Committee:	Date:
Planning and Transportation	19 July 2022
Subject: Addendum Report for Agenda item 4	Public
Boundary House 7 - 17 Jewry Street London EC3N 2EX. Application Ref. 21/00826/FULMAJ.

Whole Life Carbon Assessment

WLC benchmarking by stage (residential)

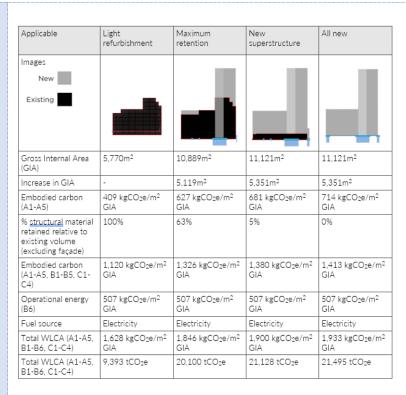
• Figure 14 is replaced with the graph below:
